HOWARD UNIVERSITY

OFFICE OF RADIATION SAFETY

**SUBJECT: ADDITIONAL INFORMATION REQUESTED FOR AMENDMENT
APPLICATION – MAIL CONTROL NOS. 582468 AND 582469**

Please see the below in response to your request for additional information to support the application to amend NRC licenses 08-00386-19 and 08-03075-07:

1 PARTIAL PLAN - BASEMENT
SCALE: 1/4" = 1'-0"

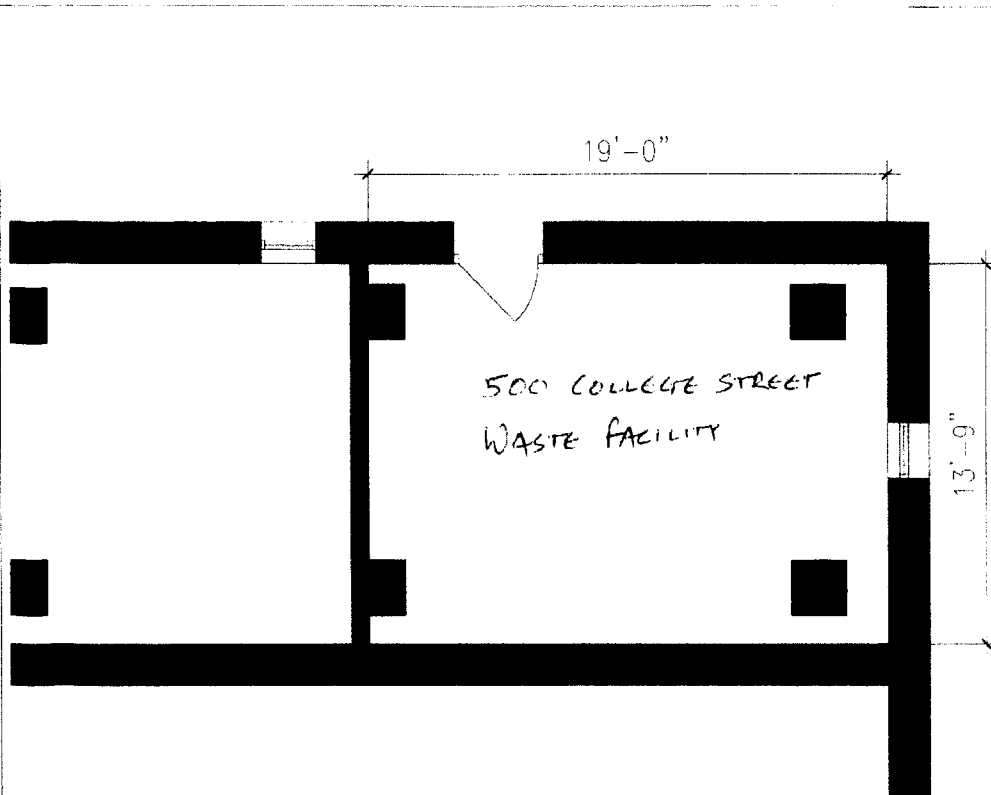
- 2. Additionally the Attachment 1 -detailed map of the site seems to be missing for the Annex I waste facility. Is this the same facility indicated as 501 Bryant Street on your 08-03075-07 license, Condition 10? Attachment 1 is also not clear for the 500 College Street facility. Although there is a map included which appears to be the area the room dimensions referenced as 13'9" x 19' are not indicated. Please clarify.**

- a. Detailed map of the sites (Basement of Annex I and 500 College Street buildings) are attached. The waste storage facilities in both of these locations are now indicated on the map. The dimensions of the waste facility in Annex I are 11'6" x 6'6", and those of the waste facility in 500 College Street are 13'9" x 19'.
